Insert Clause 168 to Clause 169 in numeric order (see later in this amendment for addition of corresponding annexes):

168. Physical Coding Sublayer (PCS), Physical Medium Attachment (PMA) sublayer and baseband medium, type 10BASE-T1M

Figure 168–13—PMA functional block diagram

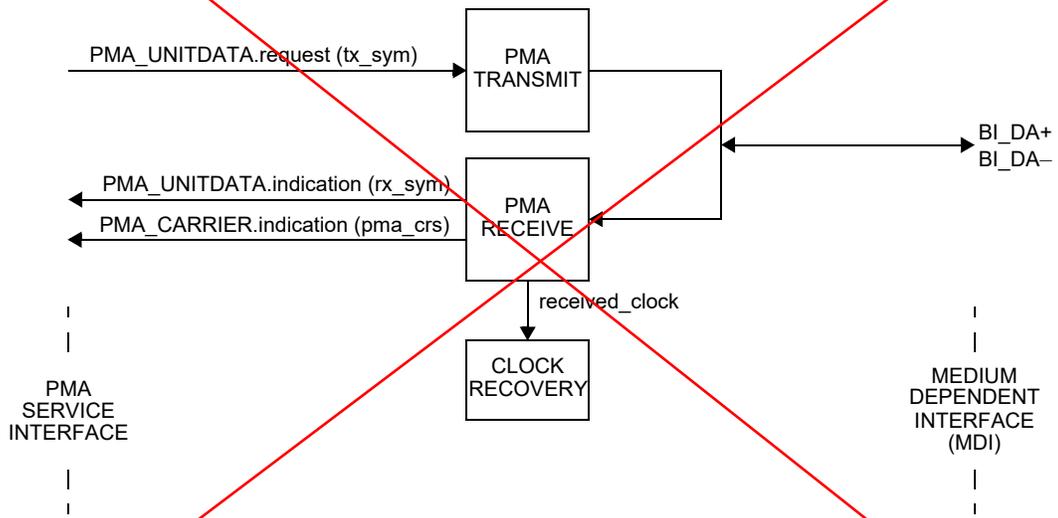
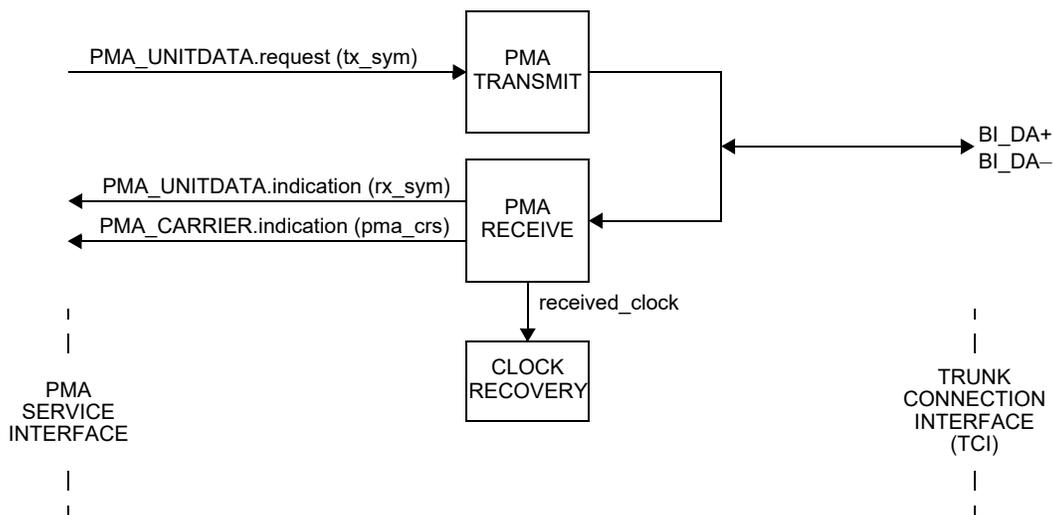
Technology Dependent Interface was removed since the PMA_LINK primitives were deleted; LINK MONITOR was removed since PCS_STATUS.indication was removed by comment 36 on D0.51

Figure 168–17—Transmitter output droop

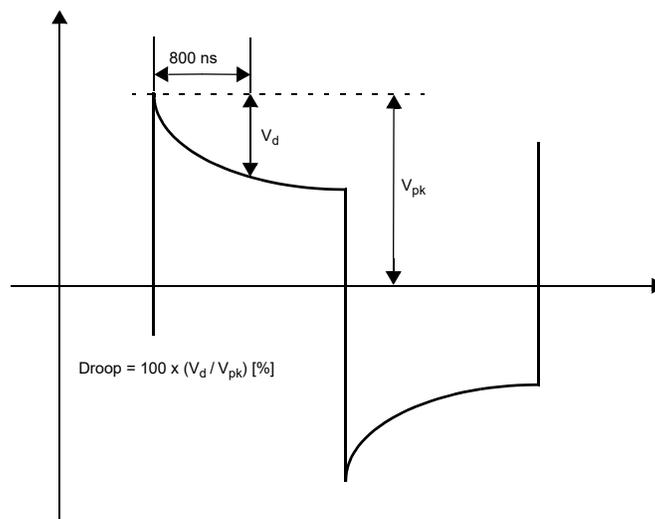
Commenters are encouraged to consider the appropriateness of an 800ns time constant droop test for a DME transmitter which must transition every 80ns. Alternatives include a traditional pulse template, a tighter PSD mask, or a different time constant. Impact of not having the test on collisions may also be considered (as well as whether the test fixture needs modification for that).

When tested using the test fixture shown in Figure 168–15 with the transmitter in test mode 2, the magnitude of both the positive and negative droop measured with respect to the initial peak value after the zero crossing and the value 800 ns after the initial peak, depicted by Figure 168–17, shall be less than 30%.

Figure 168–21—Mixing segment and reference points

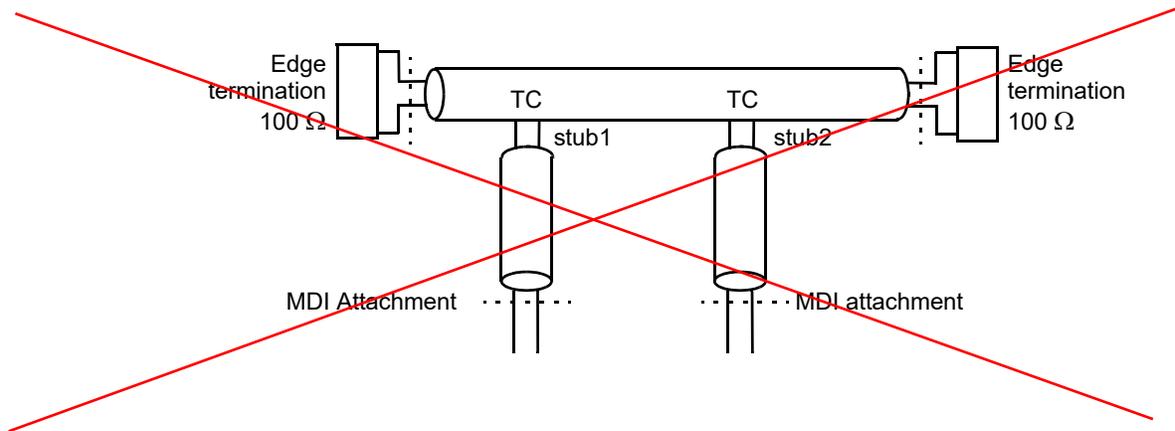
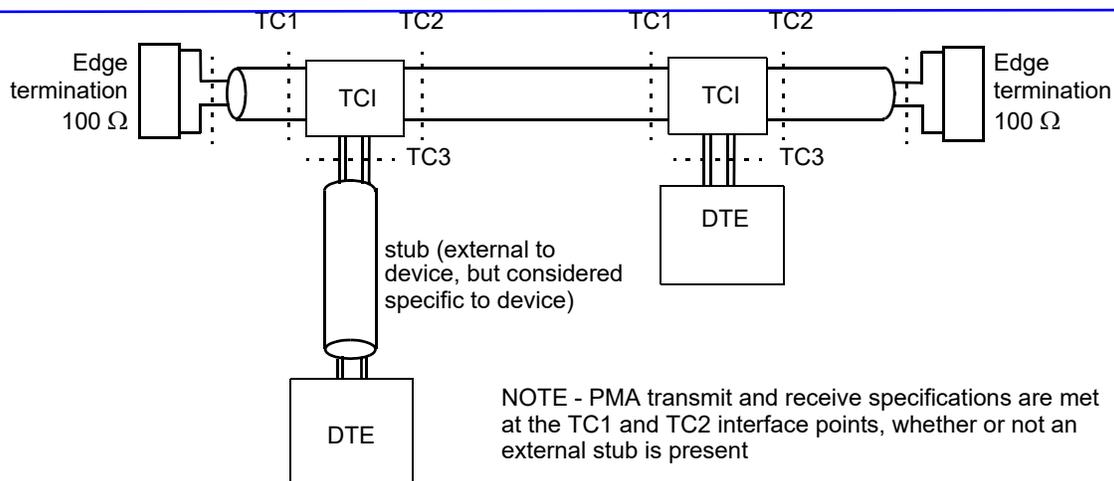
Figure 168–21 shows an example mixing segment with reference points. The mixing segment ~~specifications in~~ specifications in 168.7 are referenced to these designated points and are to be met without the ~~MDI-DTE~~ or other loads attached. The mixing segment specifications ~~are based on~~ provide for a trunk-stub configuration. ~~Other configurations may be possible, provided they meet extended from~~ the TCI. The electrical parameters in ~~this~~ 168.7 include any trunk connection interface (TCI) connecting the left and right sides of the mixing segment, but do not include any external connection such as a stub or service loop from the TCI to the DTE hardware. The example ~~configuration assumes that the~~ trunk comprises TBD m of 1.02 mm (18 AWG) 100 Ω ~~cabling and the stubs are 100-Ω balanced pairs of conductors up to 30 cm long~~ cabling, with a TCI at each location that a DTE may attach. The trunk is terminated at each end into ~~100~~

~~100 Ω, at a the point designated the ‘edge termination’. One end of the stub is designated the trunk connection (TC) and the other designated the ‘MDI attachment point’.~~
